FLUVIAL-12 SIMULATION OF SALT RIVER NEAR GILBERT ROAD CROSSING

Prepared for
Engineering Application Development and River Mechanics Branch
Engineering Division
Flood Control District of Maricopa County

Prepared by Howard H. Chang, Ph.D., P.E.

August 2009

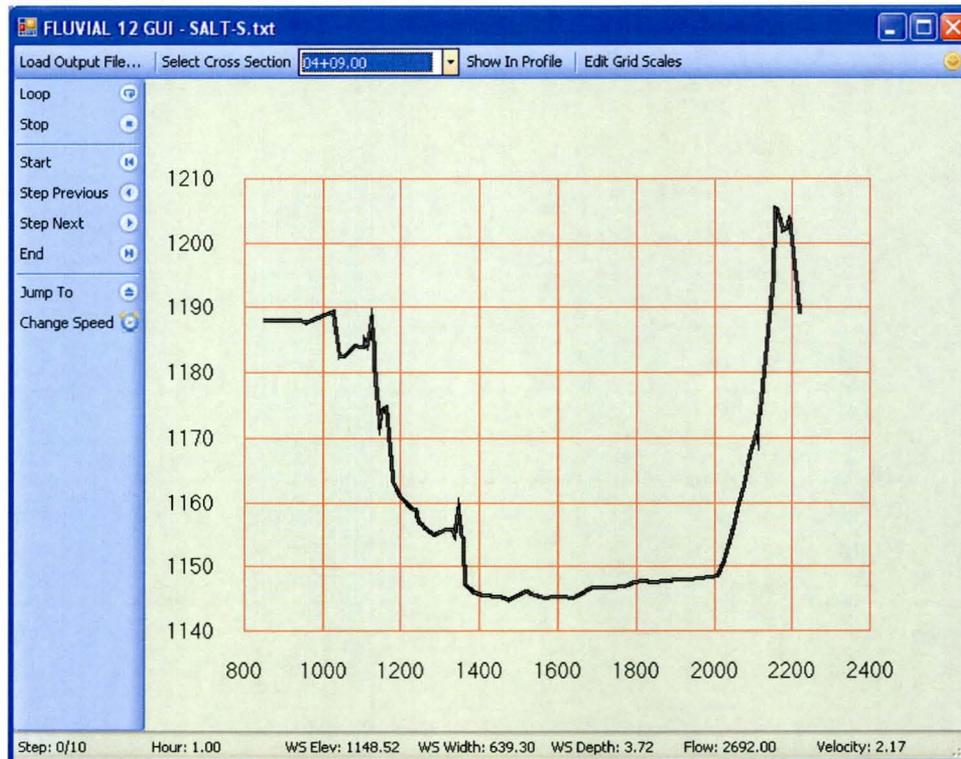
- 3) **FCD Comment (June 22, 2009):** On page 8 of the report, it is indicated that JE Fuller did the hydraulic study in 2001. However, this statement is not true. JE Fuller did their study in 2008, and WEST did their study in 2002. The JE Fuller HEC-RAS model was an updated version of the WEST model, which used the 2001 topography. In the area of Gilbert Road, both models used the 2001 topography.

Chang Consultants Response (June 29, 2009): The statement on page 8 has been revised to read as follows:

Channel Geometry Data - The channel geometry data are based on the 2001 topographic survey used in a 2008 hydraulic study by JE Fuller.

From Fluvial-12 cross-section 2.12:

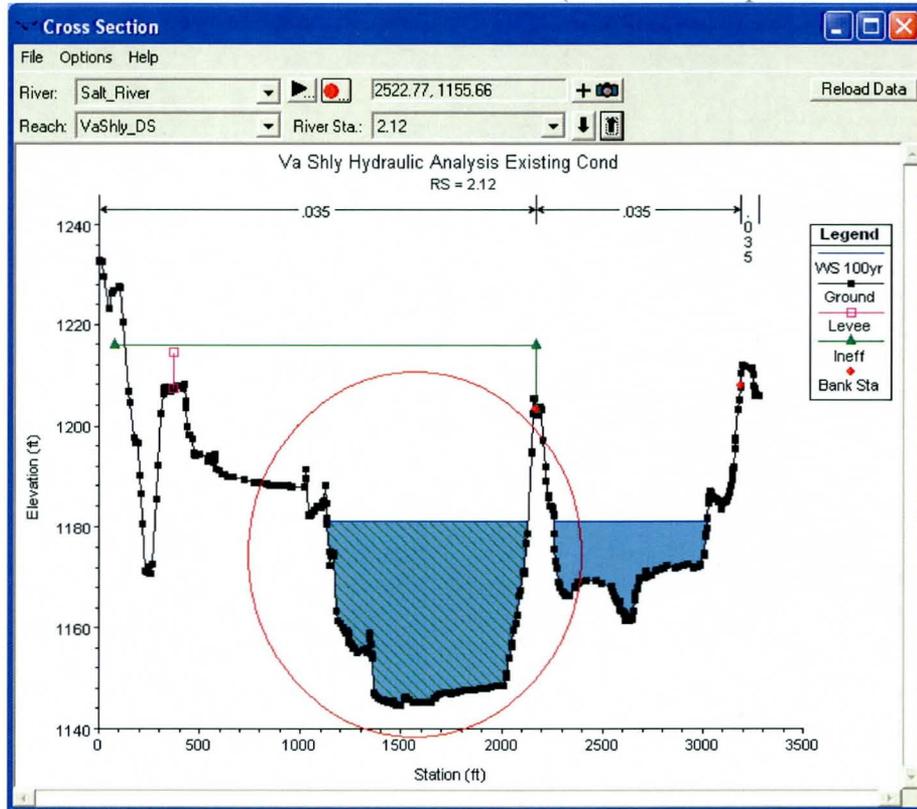
Also, there appears to be errors with multiple cross-sections in the Fluvial-12 simulations. For example, at cross-section 2.12, Fluvial-12 models an ineffective flow area as the main channel. At cross-sections 2.12 and 5.15, only a small portion of the Salt River cross-section is modeled, which may cause the flow to be artificially contained in a smaller area (e.g. cross-section 5.15). Please correct these errors and verify that all the cross-section have been converted correctly. Please see the screen captures below for the examples. As a note, in cross-sections 2.65 to 2.04, the ineffective areas along the south portion of the cross-section belong to a south channel, which is not part of the main channel and will be blocked by a levee in the future.

Chang Consultants Response (July 16, 2009): The reference for JE Fuller is now cited in the report text. The reference is also included in the list of references.

FCD Response (July 22, 2009): The reference has been added, and the cross-sections have been corrected. Comment resolved.

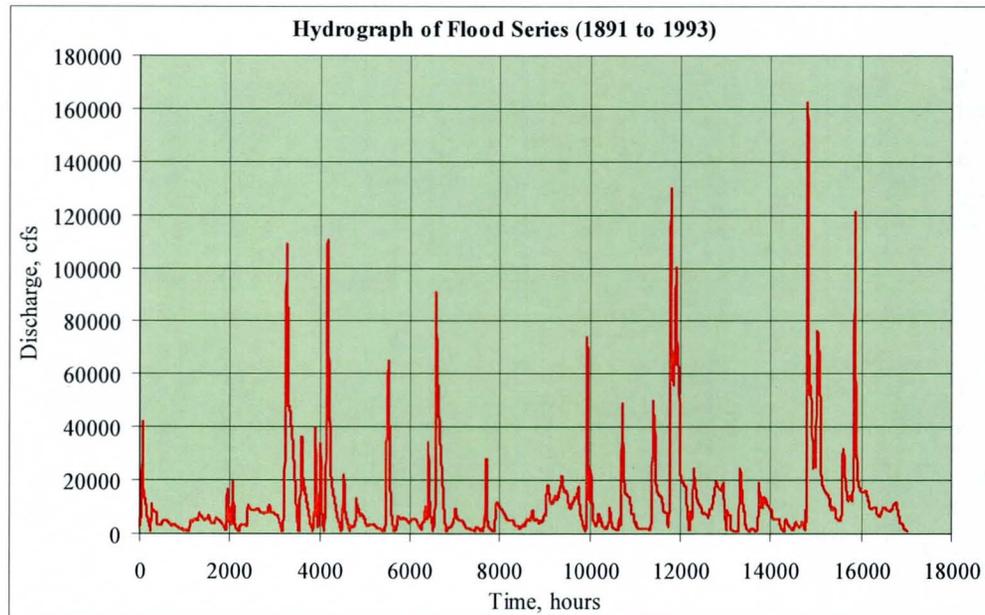
9. on page 16 in the third paragraph, the sixth sentence should have a “the” before Gilbert Road,
10. Figure 3 needs a period after 3, and
11. Figure 8 could be revised by removing the period and extraneous blue line (circled in red below).

- j. Figure 8 has been revised by removing the period and extraneous blue line

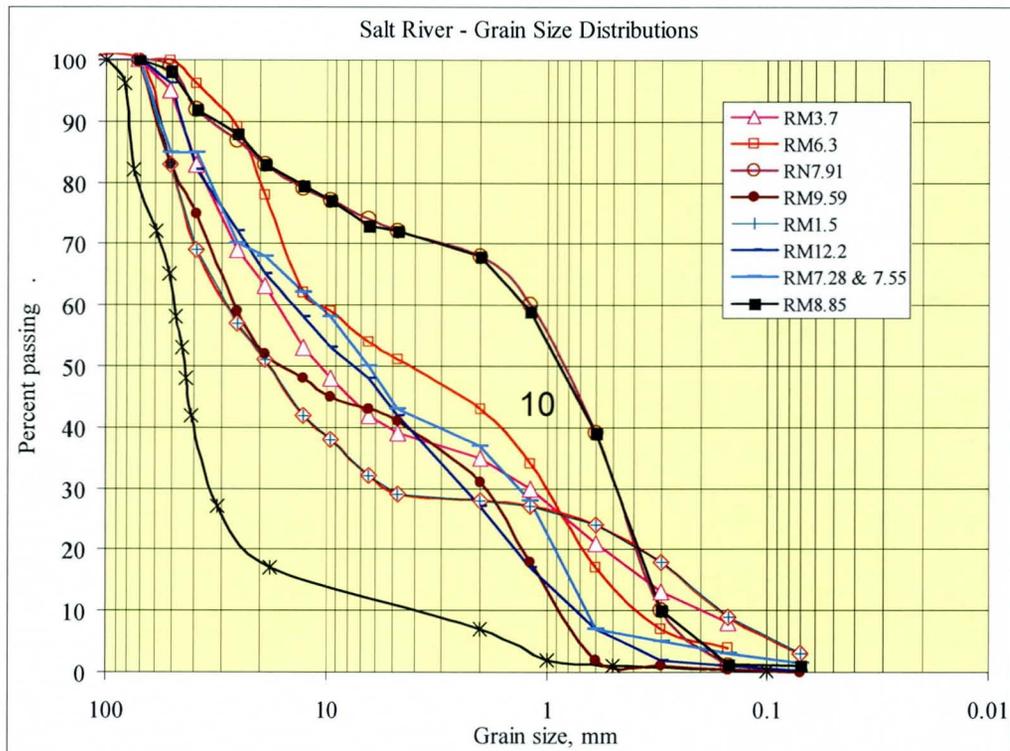
FCD Response (July 22, 2009): The development of the sediment gradations, which were used in the study, has been clarified. However, all the data labels are not shown in Figure 9 (on page 13). There are 8 data series plotted in the figure, but only 6 labels are shown. Also, it appears that one data series is plotted twice. Please revise this figure.

Chang Consultants Response (July 24, 2009): Figure 9 shows only sample gradation curves but not all the gradation curves since they are also available from existing data. To make it complete for this study, two additional curves have been added to the figure. These are:

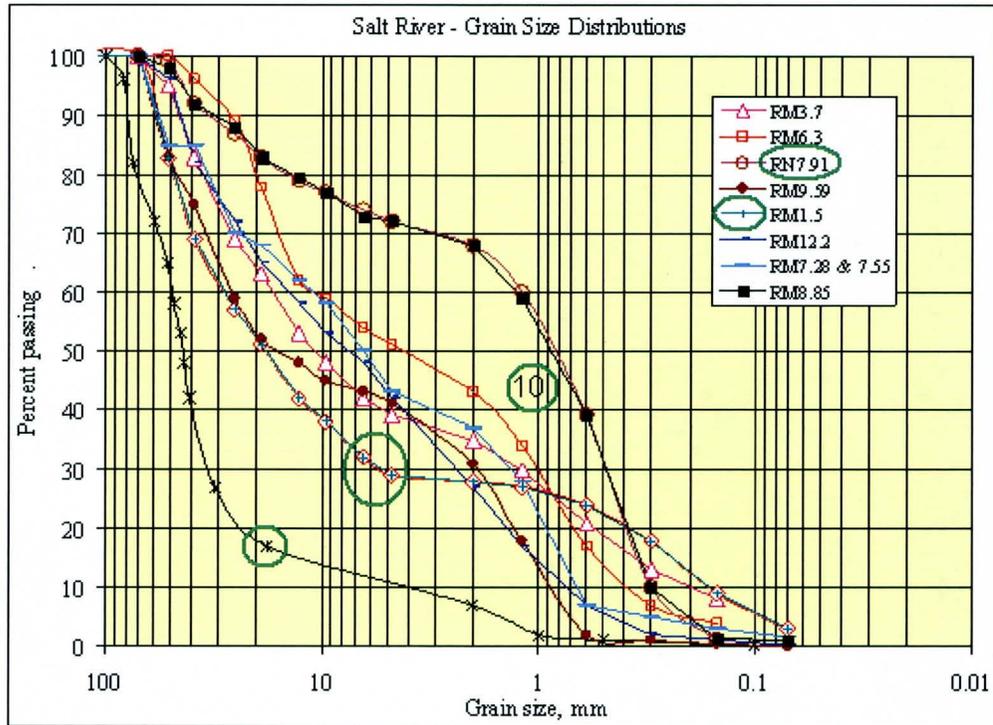
FCD Response (July 29, 2009): Additional gradations have been shown on the figure. However, there are still some minor discrepancies with the figure. These discrepancies are circled in green in the figure below. A brief list is as follows:

1. Two additional lines are shown in the figure, but not in the legend.
2. One extra symbol (for RM 1.5) is shown in the legend but not in the plot.
3. A numeral "10" is shown in the middle of the figure.
4. RN7.91 should be RM7.91.

Also, some of the data labels do not match either the Fluvial-12 cross-section or the WEST (2002) cross-section. For example, "RM12.2" is shown in the figure, but the last sediment gradation in Fluvial-12 is at cross-section 13.64 and the last gradation in the WEST report is at cross-section 13.44. Please make sure the data

labels correspond to either the Fluvial-12 model or the WEST report, and place a note, which indicates the source of the labeling, in the report. Once this figure has been revised, the final report can be submitted.
